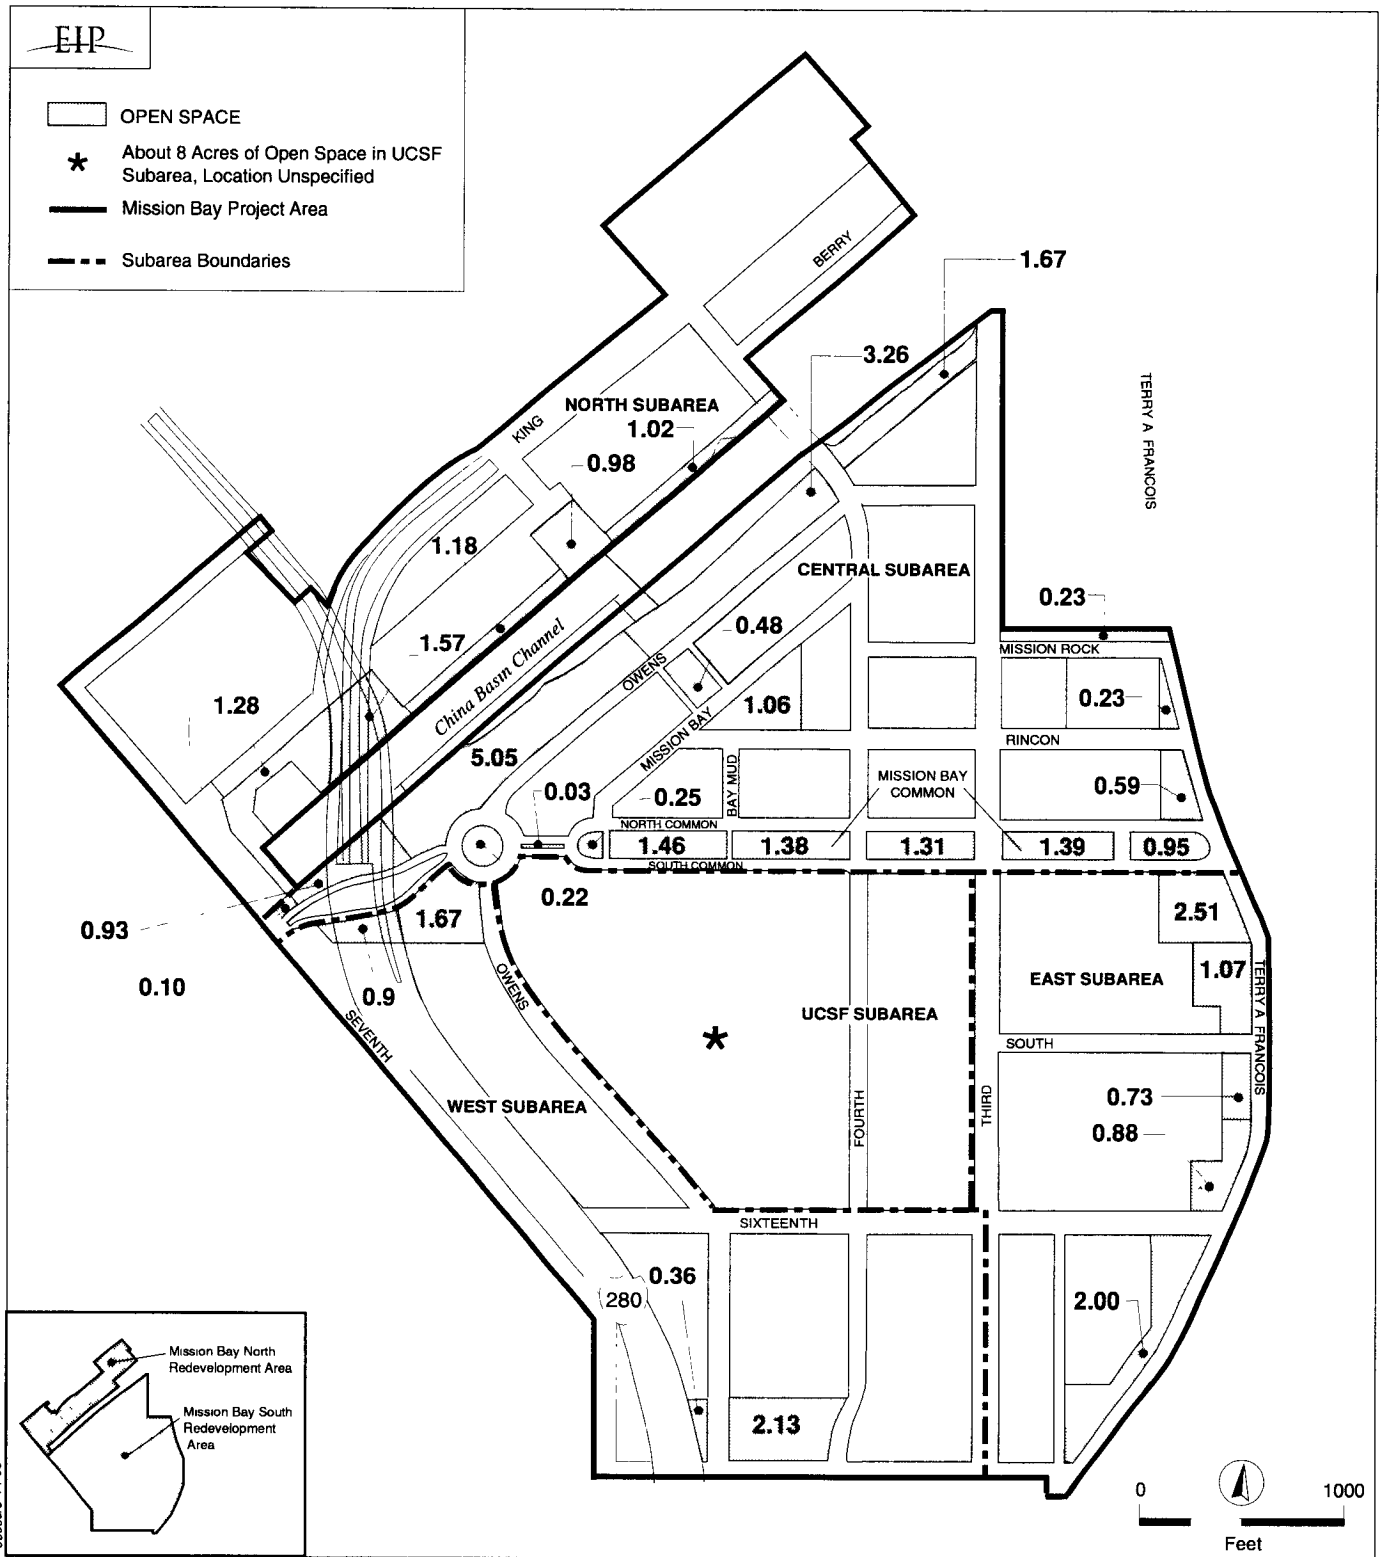
One comment asks for a breakdown of quantity and location of proposed open space. Figure XII.2 shows possible open space locations for the project based on Figure V.M.3, on p. V.M.20, with approximate acreage for each location. These are preliminary numbers but they provide a good indication of the expected distribution of open space throughout the Project Area.
